**RHODE ISLAND RADIATION CONTROL AGENCY
APPLICATION FOR REGISTRATION
OF A DIAGNOSTIC X-RAY EQUIPMENT FACILITY**

RE: DIAGNOSTIC X-RAY ROOM SHIELDING DESIGN REPORT

PLAN REVIEW SHIELDING REPORT

Shielding Recommendations: Sirona Orthophos SL 3D

Floor Plan

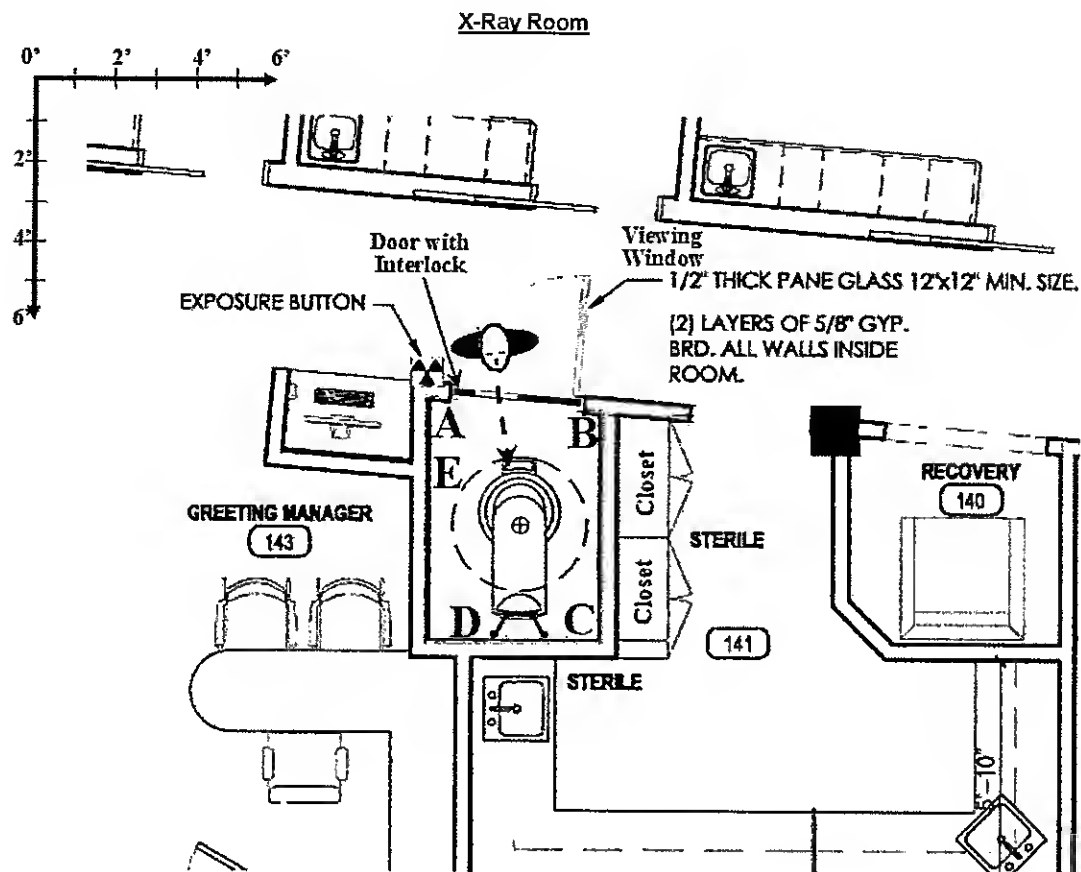
Wall Section	Protected Area	Type	Calculated Shielding (per NCRP 147)	LMP Recommended Shielding
A-B	Operator	SC	None	Door: Any door with interlock Window: 1/4" plate glass is adequate See Notes 1 & 2.
B-C	Closets	SU	None	1.25" gypsum is adequate; see Note 1.
B-C	Sterilization	SU	None	1.25" gypsum is adequate; see Note 1.
C-D	Sterilization	SU	None	1.25" gypsum is adequate; see Note 1.
D-E	Greeting Mgr.	SU	0.05 in. Gypsum	1.25" gypsum is adequate; see Note 3.
E-A	Sirona PC	SU	None	1.25" gypsum is adequate; see Note 1.
Ceiling	Adjacent Tenant	SU	None	Existing construction is adequate; see Note 1.
Floor	Ground	SU	None	Existing construction is adequate; see Note 1.

Wall Section	CBCT Distance (m)	Ceph Distance (m)	P _{Design Goal} (mR/week)	Occupancy Factor T	K _{sec} (0) (mR/week)	* Transmission Factor B(x) _{barrier}
A-B (Operator)	1.3	N/A	10	1	1.60	6.23
B-C (Closets)	1.0	N/A	2	1/20	2.60	15.36
B-C (Sterilization)	1.4	N/A	2	1/2	1.40	2.86
C-D (Sterilization)	1.3	N/A	2	1/2	1.53	2.61
D-E (Greeting Mgr.)	1.1	N/A	2	1	2.19	0.91
E-A (Sirona PC)	1.2	N/A	2	1	1.68	1.19
Ceiling (Adjacent Tenant)	2.7	N/A	2	1	0.35	5.75
Floor (Ground)	1.5	N/A	2	1/40	1.13	70.82

- **Note 1** - The calculated dose at this section of the floor plan and areas beyond this section is less than the regulatory occupational or public dose limits. Any planned/existing construction or controlled access to the area further reduces occupational and public dose.

- **Note 2 - Rhode Island regulation:** Stationary X-ray systems shall be required to have the X-ray control permanently mounted in a protected area so that the operator is required to remain in that protected area during the entire exposure. {State of Rhode Island and the Providence Plantations, Department of Health Rules and Regulations for the Control of Radiation, R23-1.3-RAD F.5(11)(a)}

Wall Section	Barrier Type	LMP Recommended Shielding (For Contractor)
A-B (Operator)	Door / Window	Door: Any door with interlock Window: 1/4" plate glass is adequate
B-C (Closets)	Wall	1.25" gypsum is adequate
B-C (Sterilization)	Wall	1.25" gypsum is adequate
C-D (Sterilization)	Wall	1.25" gypsum is adequate
D-E (Greeting Mgr.)	Wall	1.25" gypsum is adequate
E-A (Sirona PC)	Wall	1.25" gypsum is adequate
Ceiling (Adjacent Tenant)	Ceiling	Existing construction is adequate
Floor (Ground)	Floor	Existing construction is adequate
